ZP-24-143; 1555 North Avenue (RC, Ward 4) Jolley Associates / Bryan Gamache

Proposed installation of new underground fuel storage tanks, new concrete pad over tanks, new fueling drive pad, and new fueling area canopy. (Project Manager, Scott Gustin)

TO: Development Review Board
FROM: Scott Gustin
DATE: May 21, 2024
RE: ZP-24-143; 1555 North Avenue

Request: Installation of new underground fuel storage tanks, new concrete pad over tanks, new fueling drive pad, and new fueling area canopy.

1555 NORTH AVE
 BURLINGTON
STORE
 SBC NORTH AVE MOBIL
 FID# 1819

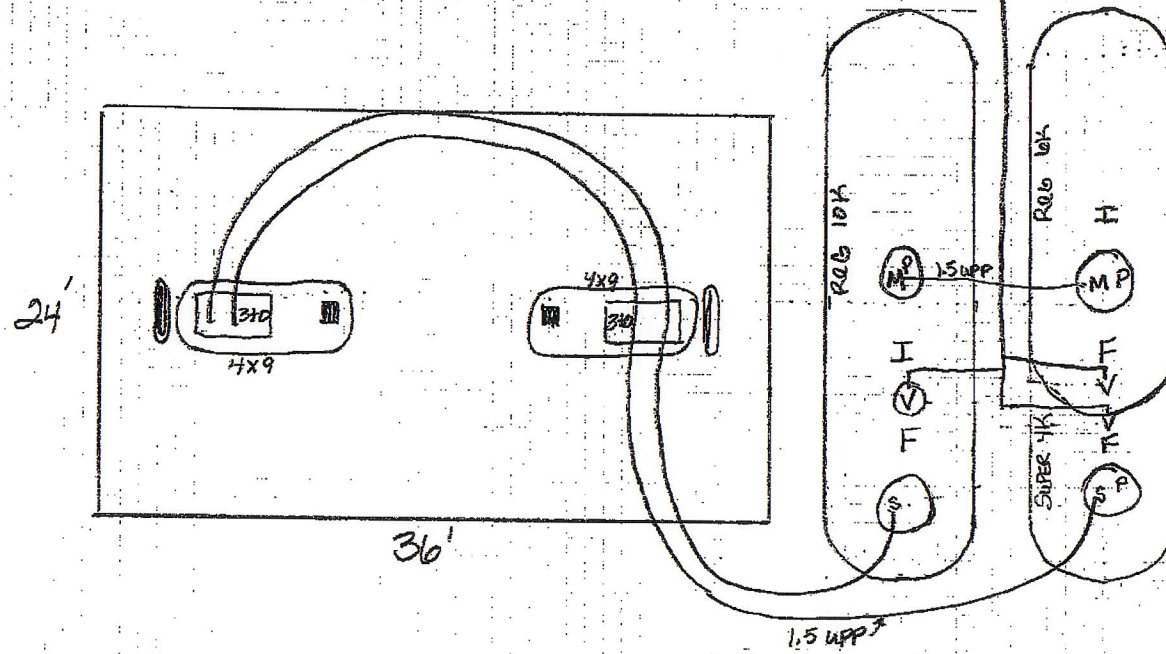
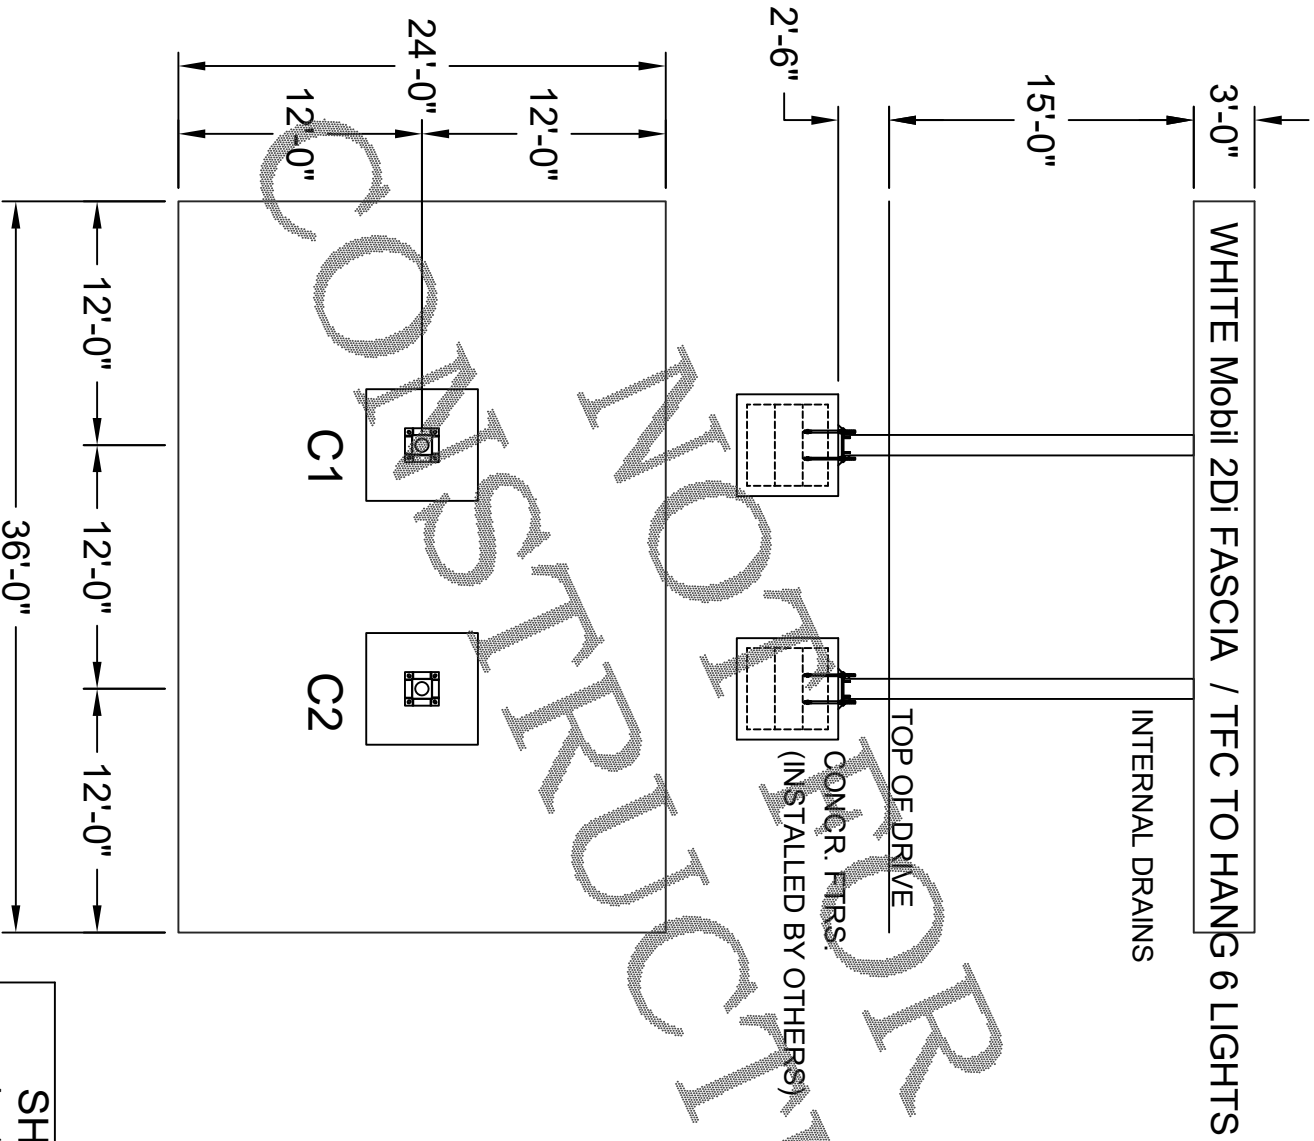
The proposed canopy is relatively small in scale and is appropriate as to the size of the area it will shelter. It will be placed so as to avoid any impacts to site circulation, and it will provide shelter to patrons refueling their vehicles. The canopy is an accessory site feature and does not adversely impact the existing convenience store building. Although not expressly included in this application, the drawings of the proposed canopy depict signage. The standards for convenience stores (Sec. 5.4.3) prohibit canopy signage. Revised project plans without canopy signage are needed. **(Affirmative finding as conditioned)**

- b. Revised project plans without canopy signage shall be submitted, subject to staff review and approval
- 2. Canopy illumination levels shall be reduced by at least 50% within one hour of the close of business. The fascia of the canopy shall be opaque.
- 3. Underground storage tank removal and replacement is subject to registration and permitting with Vermont Department of Environmental Conservation.
- 4. It is the applicant's responsibility to comply with all applicable ADA requirements.
- 5. All new construction is required to meet the Guidelines for Energy Efficient Construction pursuant to the requirements of Article VI. Energy Conservation, Section 8 of the City of Burlington Code of Ordinances.
- 6. Standard Conditions 1-15.

LIGHTING PROPOSAL LD-160171

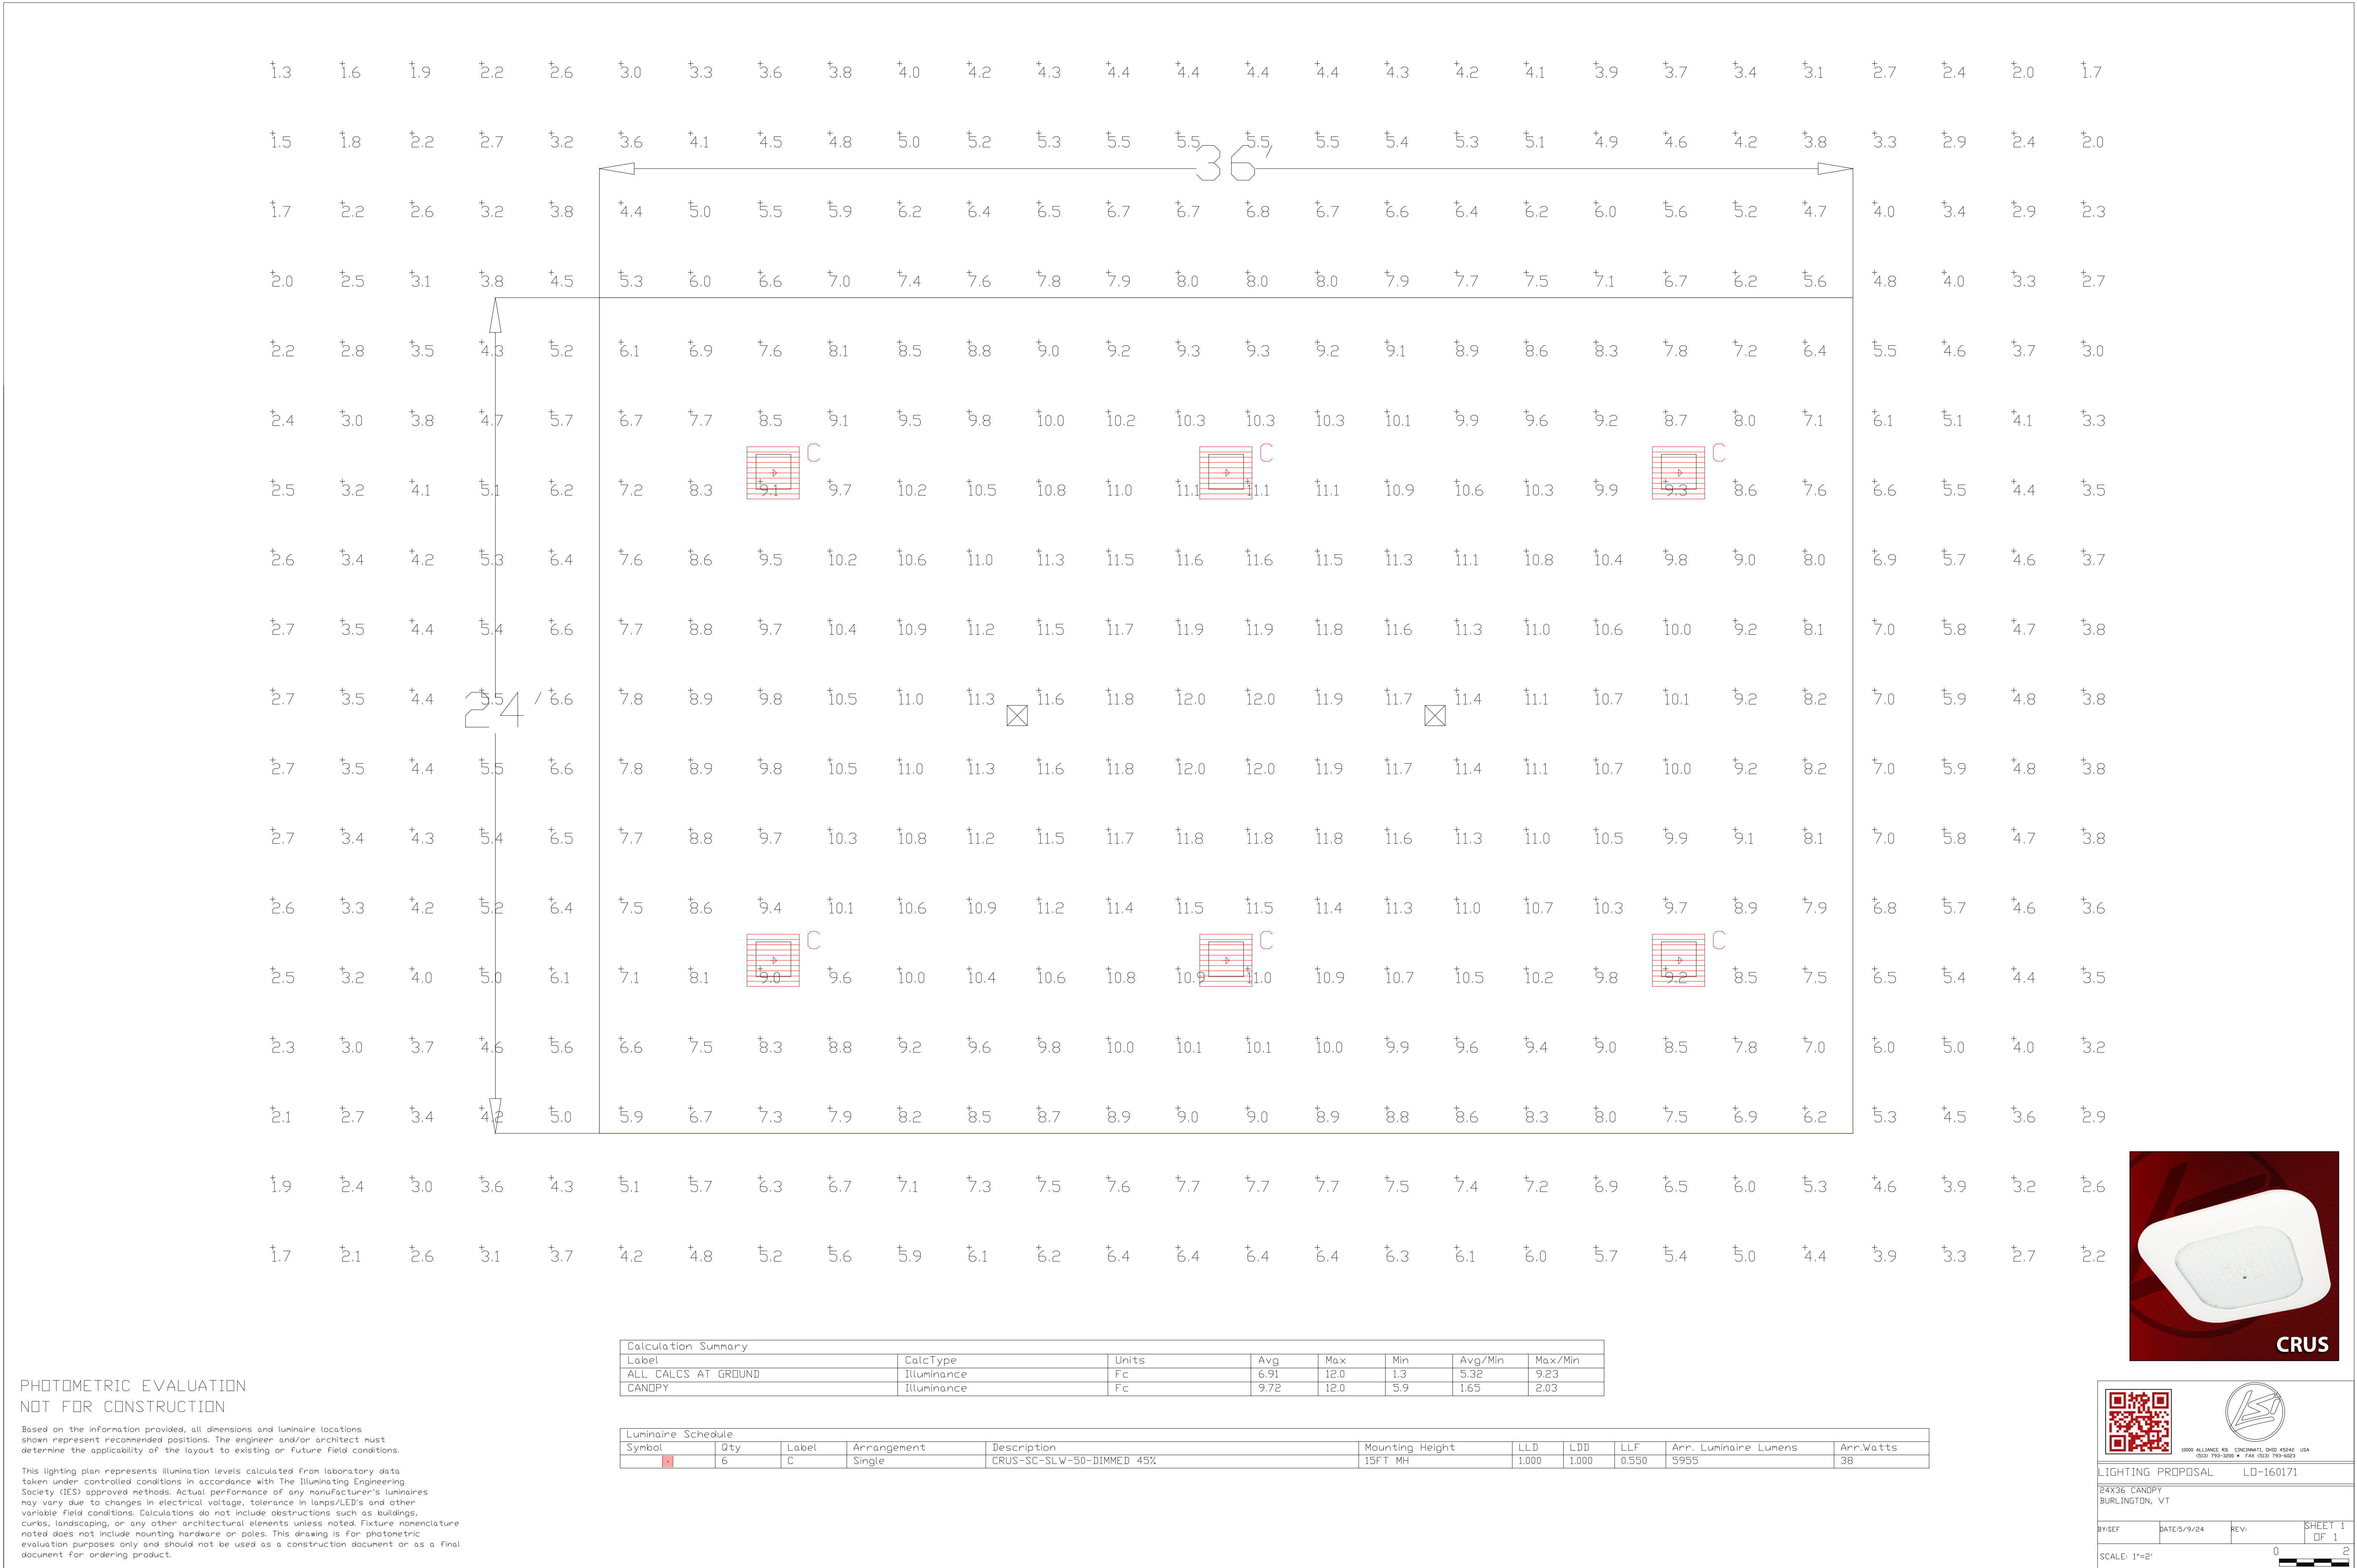
The proposed canopy will be illuminated underneath. As required, a fixture cut sheet and a photometric plan have been provided. Six LED canopy light fixtures are proposed, and illumination levels average to 5.3 footcandles as depicted in the photometric plan. The fixture and illumination levels are acceptable. There is nothing to indicate the outer sides of the canopy will be illuminated. The applicable criteria for canopy illumination (subsection f, 3) require that the sides of the canopy (fascia) be opaque. Canopy illumination must be reduced by at least 50% one hour after the close of business. **(Affirmative finding as conditioned)**
